UNITED STATES PATENT AND TRADEMARK OFFICE

Office Action Summary	Application No. 10/693,473	Applicant(s) GRAMLING, KARL	
	Examiner Jessica Laux	Art Unit 3635

DETAILED ACTION***Double Patenting***

Fig. 4

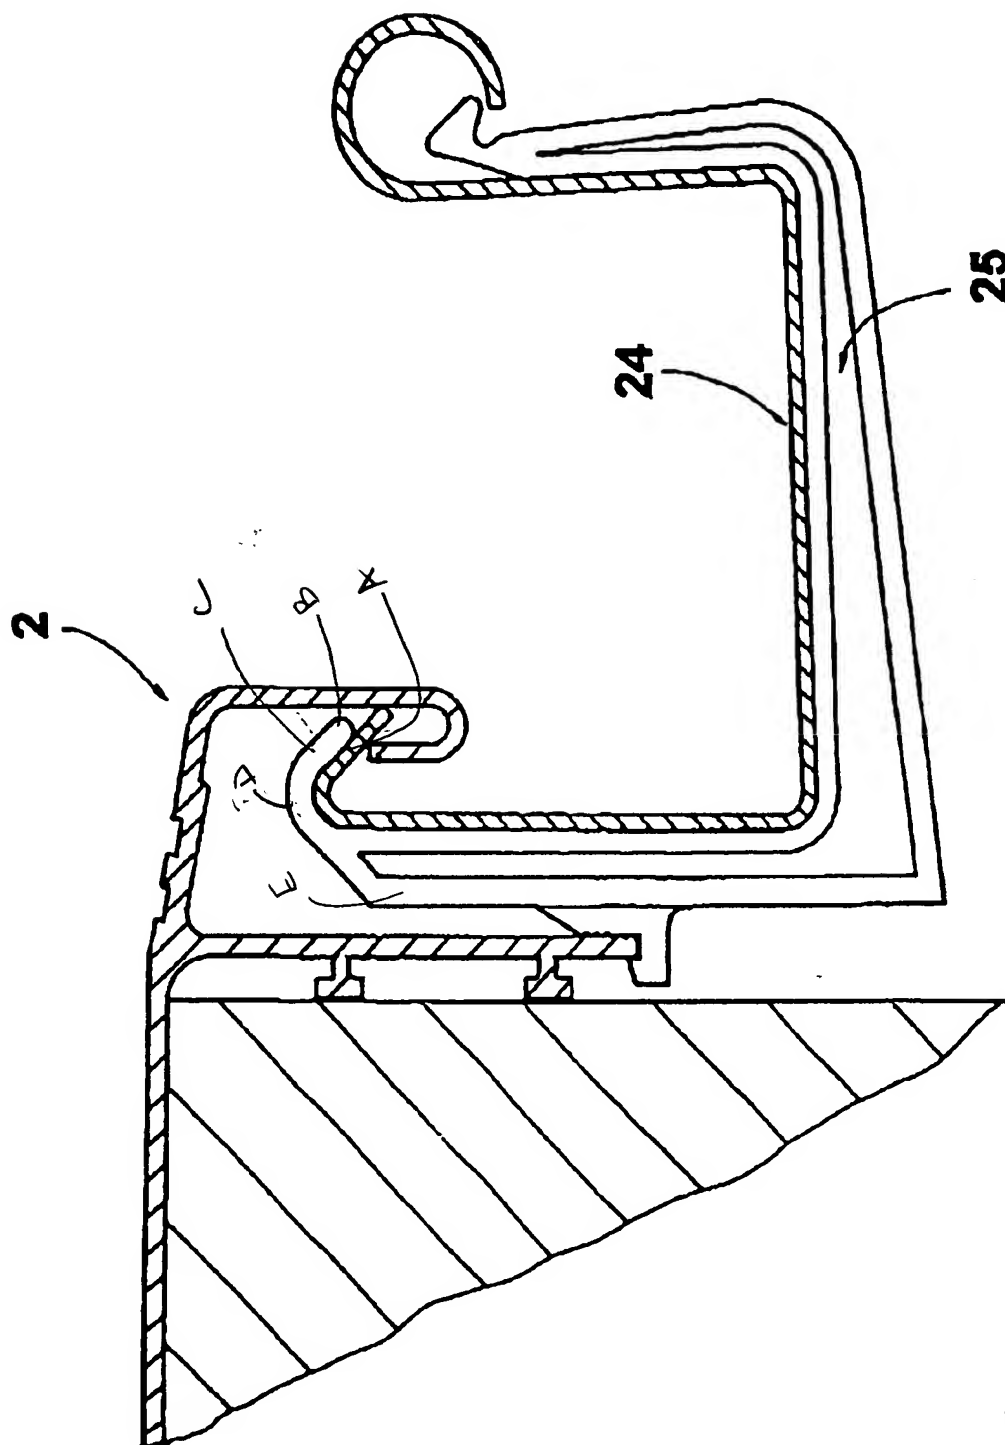
Claims 1 and 6-12 are rejected under 35 U.S.C. 102(b) as being anticipated by Schluter (5960591).

In regards to claim 1: Schluter discloses a gutter retaining system comprised of a clip (Figure 4, element 25), a retaining member (Figure 4, element 2), and a gutter (Figure 4, element 24). Schluter also discloses a gutter clip as having a locking tip (element A, see attached sheet) contiguous with a nib end (element B, see attached sheet), the nib end being adjacent to a hanger portion (element C, see attached sheet), the hanger portion being contiguous to a U portion (element D, see attached sheet), the U portion being adjacent to a vertical portion (element E, see attached sheet), the hanger portion and vertical portion being approximately parallel and the nib end is angled outward from the hanger portion and the locking tip is angled inward toward the vertical portion whereby the clip is locked within and between the gutter and retaining member (Figure 4).

In regards to claim 6: Schluter discloses a base adjacent the vertical portion (Figure 4).

In regards to claim 7: Schluter discloses an extension adjacent the base (Figure 4).

In regards to claim 8: Schluter discloses a back face mounted against the gutter back wall (Figure 4).

In regards to claim 9: Schluter discloses a first elbow between the vertical portion and the base (Figure 4).

In regards to claim 10: Schluter discloses a second elbow between the base and the extension (Figure 4).

In regards to claim 11: Schluter discloses a lower U portion adjacent to the extension (Figure 4).

In regards to claim 12: Schluter discloses an end adjacent the lower U portion (Figure 4).
